URGENT FIELD SAFETY NOTICE

GEHC Ref# 32047

RE: Infant Warmer System (IWS) Hot “Heater Head” Screw could Fall onto the Bed

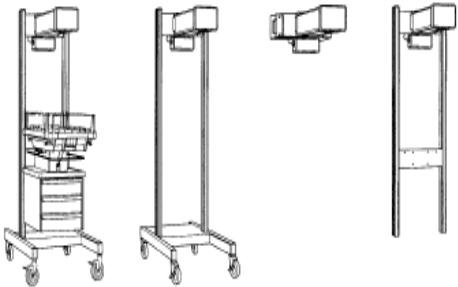
Hot screws from the “Heater Head” of the IWS could fall onto the bed if the “Heater Head” assembly has been improperly serviced. This situation can be clinically hazardous because thermal injury to a patient could result. Two injuries have been reported as a result of this issue.

The potential for this issue to occur is only present if the “Heater Head” assembly has been improperly serviced.

As a result, if “Heater Head” service has been performed in the past, check to ensure that the screws are tightened as soon as the unit becomes available.

If the “Heater Head” assembly has not been serviced, check to ensure that the screws are tightened as part of your next regularly scheduled annual Preventive Maintenance check.

The attached Service Manual Addendum provides instructions for checking and tightening the screws. During each annual Preventive Maintenance check, continue to ensure that the screws are tight.
